Access Compliance Report Public Rights-of-Way (Curb Ramps)

Main Street: WALLINGSFORD_RD		Cross Street: DONNIE_ANN_RD		Location:	SW
ADA ID: RPRK220218142051	Ramp Type:Type 1 - Perpendicular Diagonal Initial Pass/Fail: Pass		Overall Compliance: No	Severity Score:	10
Codes/Mitigation Info/Possible Solution			Field Measurements/Component Compliance

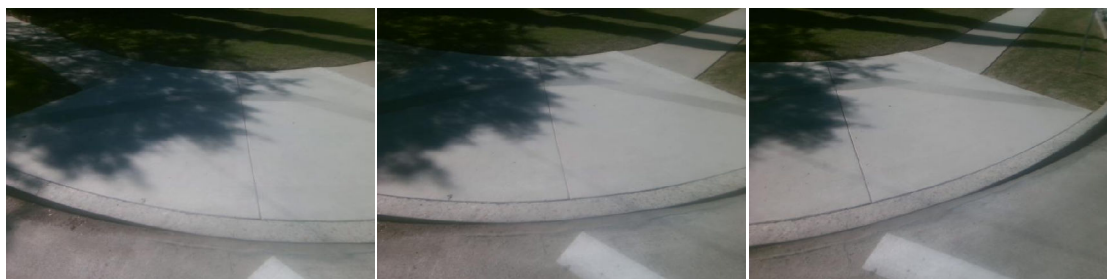
R304.2.2-Perp, R304.3.2-Para, R305, STD 1115

Remove & Replace Curb Ramp With Two New Directional Ramps or Equivalent.
